WCAP-15791-P, Rev. 1
Project Number 694

Subject: Westinghouse Owners Group
Response to the NRC Request for Additional Information (RAI)
Regarding Review of WCAP-15791-P, Rev. 1, (Proprietary), "Risk-
Informed Evaluation of Extensions to Containment Isolation Valve
Completion Times" (PA-LSC-0029) (MUHP-3010)

Attachment to WOG-05-119
Responses to the NRC's RAIs on WCAP-15791-P, Rev. 1

Figure 1
Approach for Assessing LERF for an Inoperable Containment Isolation Valve

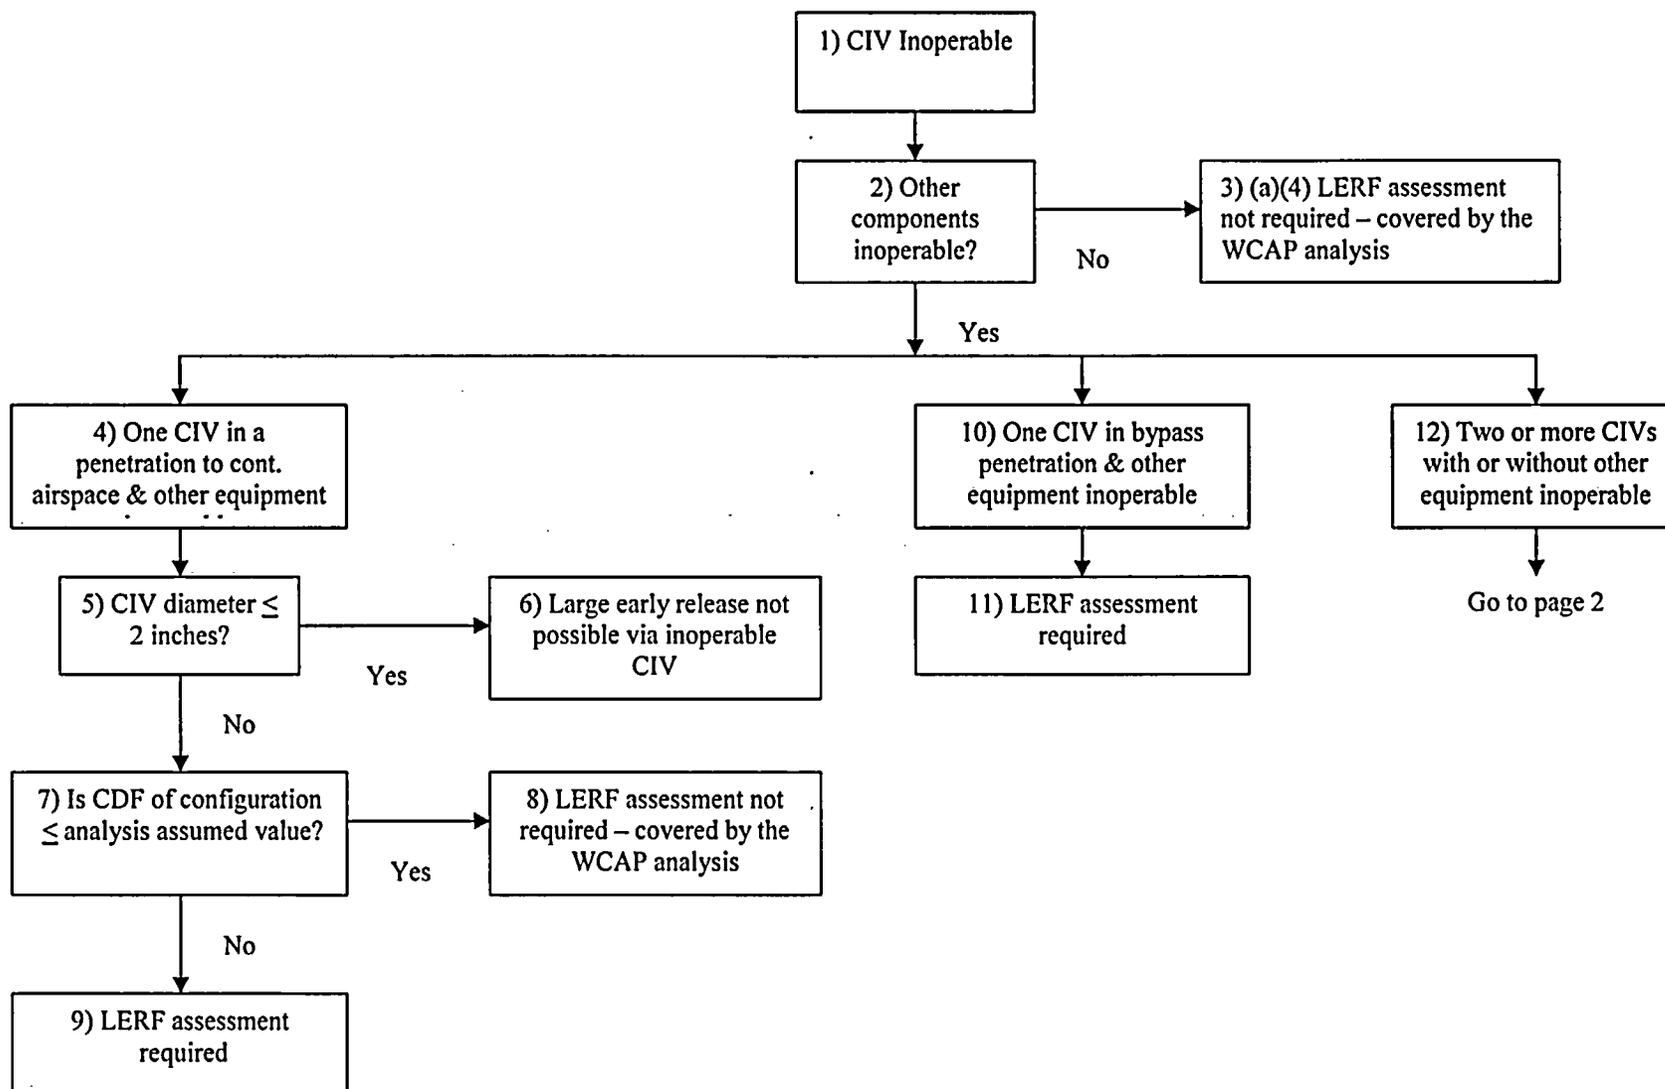
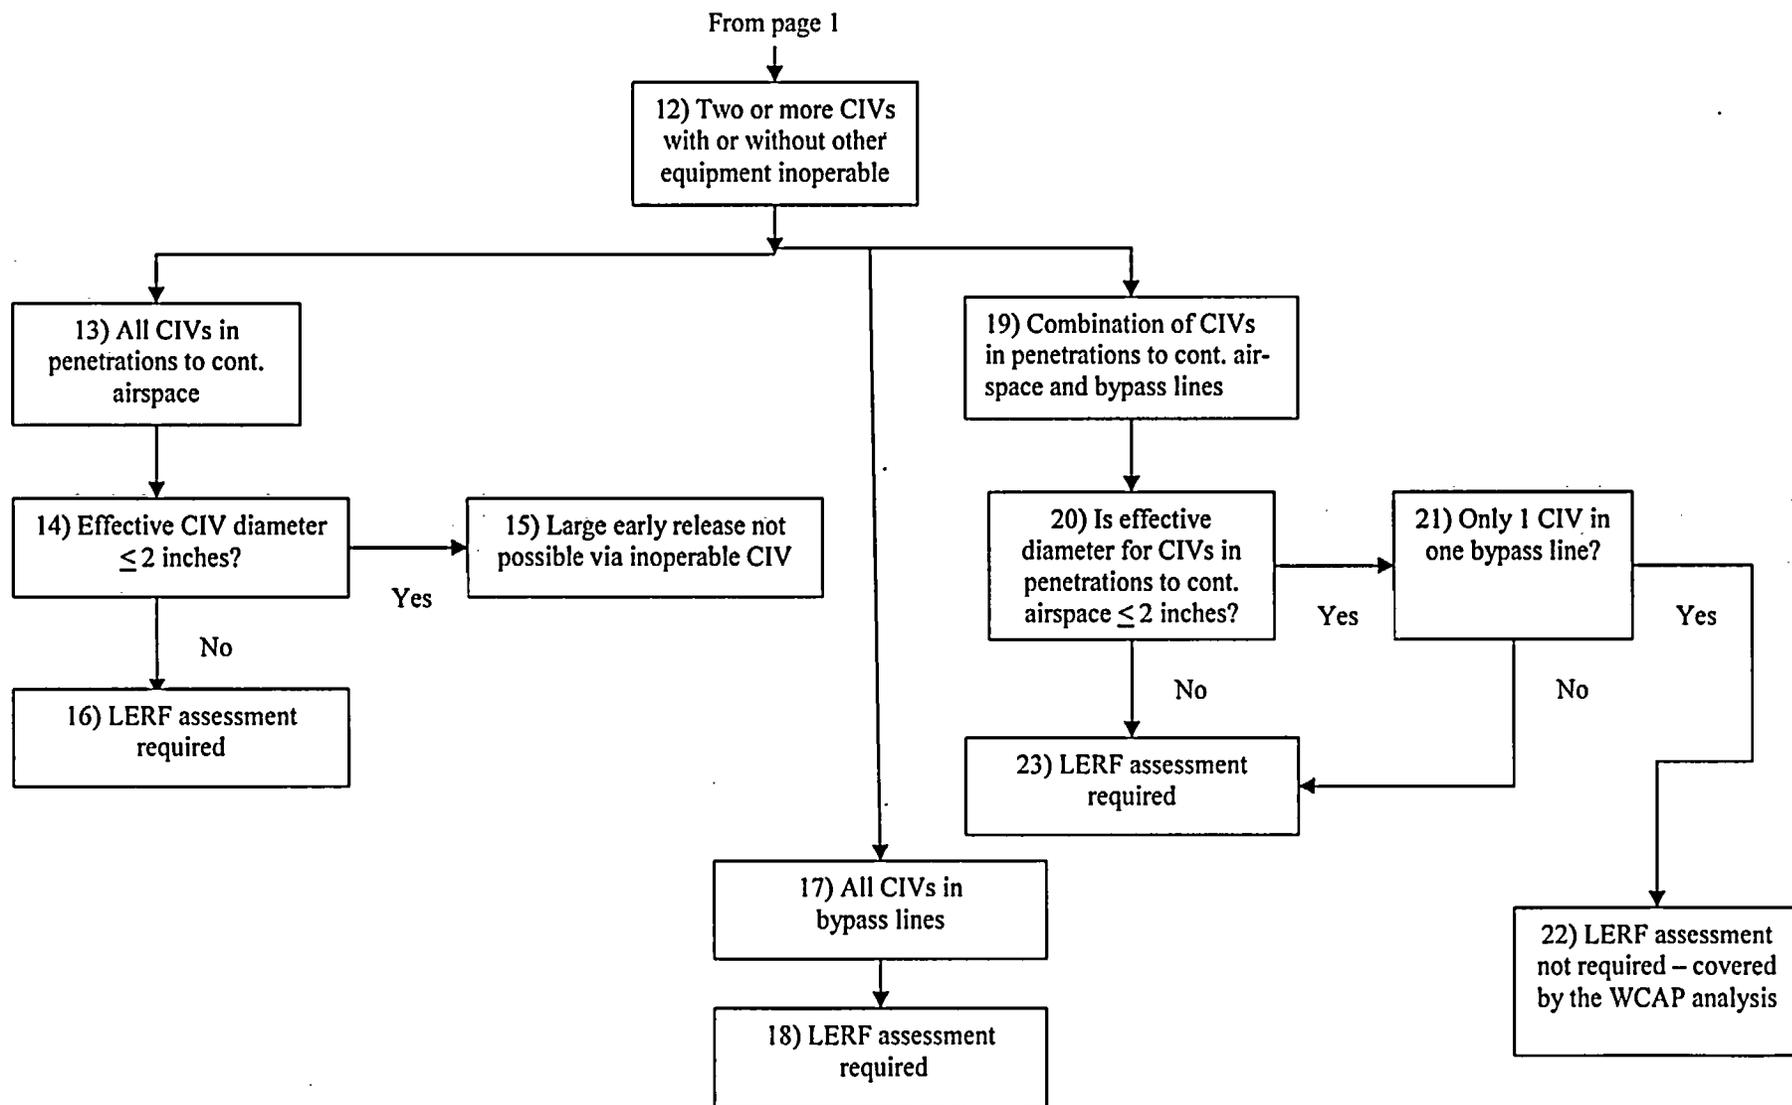
RAI 1: A Tier 3 program ensures that while a CIV is in an LCO condition, additional activities will not be performed that could further degrade the capability of the plant to respond to a condition the inoperable CIV or system was designed to mitigate, and as a result, increase plant risk beyond that assumed by the Topical Report analysis. Tier 3 programs, as implemented by the maintenance rule of 10 CFR 50.65(a)(4) during CIV maintenance are to: (1) ensure that additional maintenance does not increase the likelihood of an initiating event intended to be mitigated by the out-of-service equipment, (2) evaluate the effects of additional equipment out-of-service during CIV maintenance activities that would adversely impact CIV CT risk such as from redundant systems or components, and (3) evaluate the impact of maintenance on equipment or systems assumed to remain operable by the CIV CT analysis.

The staff is concerned that configuration risk management as implemented under the maintenance rule is inadequate to evaluate the risk impact of CIVs in maintenance or repair such that the assumptions of WCAP-15791 remain valid. The extension of the CTs for CIVs generally does not have a significant impact on CDF but does impact LERF/ICLERP (containment isolation). The TS allow multiple condition entry for CIVs but the topical report analyses are based on a single PCIV CT and therefore cumulative risk must also be evaluated for multiple PCIV LCOs. Plant TIER 3 programs that are based on the maintenance rule generally do not provide a quantitatively or qualitatively assessment of LERF. WCAP-15791 provide limited, if any, guidance on performing a TIER 3 LERF analysis either for single or multiple CIV CTs. Quantitative risk assessment is not required by the maintenance rule and in general the TIER 3 assessment is done with only a level 1 CDF analysis. Since the extension of a CIV CT mainly impacts LERF/ICLERP it is the staff's concern that the evaluation of CIVs in a TIER 3 configuration risk management program is limited in that the configuration risk assessment may be incomplete for CIVs in maintenance or repair (only a quantitative or qualitative CDF assessment with a limited qualitative LERF/ICLERP assessment).

A review of the NEI Guidance 93-01, revision 2, Section 11.3.7.1 as endorsed by RG 1.1821 states that qualitative methods is an acceptable approach for establishing risk management actions for (a)(4) assessments in general. Section 11.3.7.2 provides guidance on establishing action thresholds based in part on the EPRI PSA applications guide EPRI-TR-105396. NEI-93-01 guidance states that an acceptable alternative for (a)(4) implementation would include establishing ICDP and ILERP risk management action thresholds. NEI-93-01 also states that due to differences in plant type and design, there is acknowledged variability in baseline core damage frequency and large early release frequency. Further, there is variability in containment performance that may impact the relationship between baseline core damage frequency and baseline large early release frequency for a given plant or class of plants. Finally 93-01 states that therefore, the determination of the appropriate method or combination of methods as discussed above (as presented in 93-01), and the corresponding quantitative risk management action thresholds are plant unique activities.

The topical report WCAP-15791 implementation of RG 1.177 Tier 3 guidelines generally implies the assessment of risk with respect to CDF. However, the proposed CIV CT impacts containment isolation and consequently LERF as well as CDF. Therefore, a licensee's CRMP, including those implemented under the maintenance rule of 10 CFR 50.65(a)(4), must be enhanced to include a LERF methodology/assessment and must be documented in a licensee's plant-specific submittal. Provide a discussion on the LERF methodology to be employed by WCAP-15791 TIER 3 assessments on a plant specific basis as part of topical report WCAP-15791 implementation.

Figure 1 provides the process to assess the LERF/LERP impact of inoperable CIVs. This process addresses the inoperability of 1 or more CIVs that could be in penetrations connected to the containment airspace or in a containment bypass line. Each box in the approach is discussed in the following.

Block 1. This block is the entry point for the approach; a CIV is inoperable.

Block 2. This block sorts on other inoperable components. If there are no other inoperable components, the path leads to block 3. If there are other inoperable components, including other inoperable CIVs, the path leads to block 4, 10, or 12, depending on the other components that are inoperable.

Block 3. If the only inoperable component is a CIV, then the analysis in WCAP-15791-P, Rev. 1 is applicable. The CT listed for this CIV is taken directly from the WCAP analysis which assumed only one inoperable CIV. The WCAP analysis assessed the impact on LERF and ICLERP, therefore, the configuration is acceptable and no additional evaluation is required to meet the Tier 3 requirement.

Block 4. This path is followed if the one CIV in a penetration to the containment airspace is inoperable and other equipment (not another CIV) is also inoperable, such as an auxiliary feedwater pump. In this situation the CDF may be increased due to the additional component inoperability. This additional inoperability, and potentially increased CDF, may not be explicitly covered by the analysis and should be considered.

Block 5. This block sorts on the CIV size. A containment hole size of 2 inches in diameter is the threshold for a large release; a hole size less than or equal to a 2 inch diameter will not result in a large release.

Block 6. If the diameter of the CIV is less than or equal to 2 inches, then a large release is not possible. Therefore, regardless of the potential impact on CDF of the additional inoperable component(s) the WCAP analysis is applicable, the configuration (with regard to large early release) is acceptable, and no additional large early release evaluation is required to meet the Tier 3 requirement.

Block 7. This block sorts on the CDF of the specific plant configuration under consideration. The WCAP generic analysis assumed a total CDF of $1E-04/\text{yr}$. If a plant specific analysis was completed, then this plant specific value needs to be considered in this block.

Block 8. If the configuration specific CDF is less than or equal to the value used in the analysis ($1E-04/\text{yr}$ in the generic analysis or a plant specific CDF if a plant specific analysis was completed), then the WCAP analysis is applicable, the configuration (with regard to large early release) is acceptable, and no additional large early release evaluation is required to meet the Tier 3 requirement.

Block 9. If the configuration specific CDF is greater than the value used in the analysis ($1E-04/\text{yr}$ in the generic analysis or a plant specific CDF if a plant specific analysis was completed), then a large early release assessment for the plant specific configuration will need to be completed to meet the Tier 3 requirement.

Block 10. This path is followed if the CIV is located in a containment bypass line and other equipment (not another CIV) is also inoperable. In this situation, the large early release parameters may be impacted, not by the CIV in the bypass line which is covered by the WCAP analysis, but in conjunction with the increased CDF from the additional inoperable equipment and containment isolation failure.

Block 11. Due to the combination of an inoperable CIV in a containment bypass line and other inoperable equipment impacting the plant CDF, and LERF via containment isolation failure, a large early release assessment for the plant specific configuration will need to be completed to meet the Tier 3 requirement.

Block 12. This path is followed if two or more CIVs are inoperable in difference penetrations. The same path is followed whether or not additional equipment (not CIVs) is also inoperable.

Block 13. This path is followed if all the inoperable CIVs are in penetrations to the containment airspace, with or without additional equipment inoperable. The WCAP analysis only considered one inoperable CIV at a time. Therefore, except for the exception in block 14, large early release assessments are required.

Block 14. This block sorts on the effective CIV size. A containment hole size of 2 inches in diameter is the threshold for a large release; a hole size less than or equal to a 2 inch diameter will not result in a large release.

Block 15. If the effective diameter of the CIV is less than or equal to 2 inches, then a large release is not possible. Therefore, regardless of the potential impact on CDF of the additional inoperable component(s) the WCAP analysis is applicable, the configuration (with regard to large early release) is acceptable, and no additional large early release (a)(4) evaluation is required to meet the Tier 3 requirement.

where: effective diameter = $((\text{diameter hole } 1)^2 + (\text{diameter hole } 2)^2 + (\text{diameter hole } 3)^2 + \dots)^{0.5}$

Block 16. If the effective diameter is greater than 2 inches, then a large release is possible. Since the WCAP analysis only considered single inoperable CIVs, a large early release assessment for the plant specific configuration will need to be completed to meet the Tier 3 requirement.

Block 17. This path is followed if the inoperable CIVs are located in different containment bypass lines, with or without additional equipment inoperable.

Block 18. Since the WCAP analysis only considered a single inoperable CIV, a large early release assessment for the plant specific configuration will need to be completed to meet the Tier 3 requirement.

Block 19. This path is followed if the inoperable CIVs are located in a combination of bypass lines and penetrations to the containment airspace. This could impact one or more bypass lines and one or more penetrations to the containment airspace.

Block 20. This block sorts on the effective diameter for the CIVs in penetrations to the containment airspace. A containment effective hole size of 2 inches in diameter is the threshold for a large release; a containment effective hole size less than or equal to a 2 inch diameter will not result in a large release.

Block 21. This block further sorts on the number of bypass lines impacted by the inoperable CIVs.

Block 22. If only one bypass line is impacted by the inoperable CIVs, and the effective diameter for the CIVs in penetrations to the containment airspace is ≤ 2 inches per block 20, then the WCAP analysis is applicable, the configuration (with regard to large early release) is acceptable, and no additional large early release evaluation is required to meet the Tier 3 requirement.

Block 23. Since the WCAP analysis only considered a single inoperable CIV, a large early release assessment for the plant specific configuration will need to be completed to meet the Tier 3 requirement.
